**LP22-00002/SEP22-0023: All Comment Letters  
13 pages**

Re: Sunfisher Subdivision—SEPA DNS (File Nos. SEP22-0023; LP22-00002)  
US 12 MP 130.22

**Subject:** LP22-00002 Sunfisher LCC 16.05.090 Review

f) Adequacy of Lot Arrangement and Driveway & Building Access

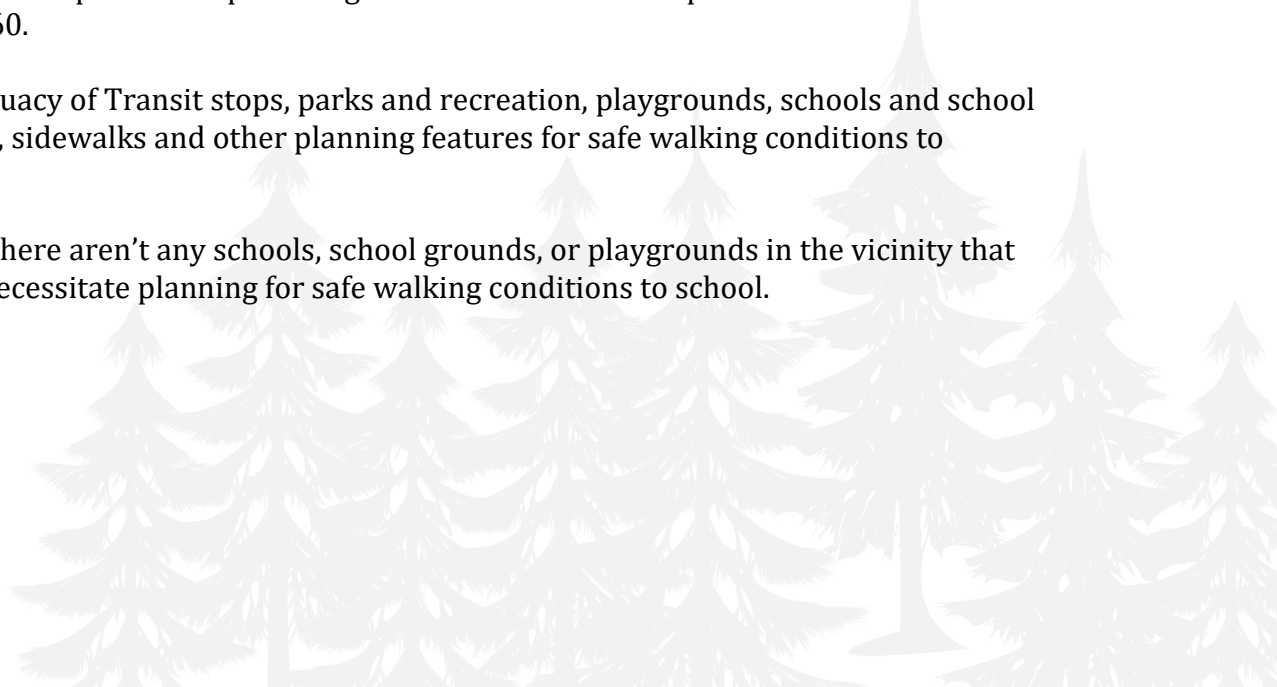
Lot arrangement will need to be adjusted to accommodate sixty feet of right-of-way to provide acceptable access to all lots via public roads. The arrangement shown provides adequate access for private roads.
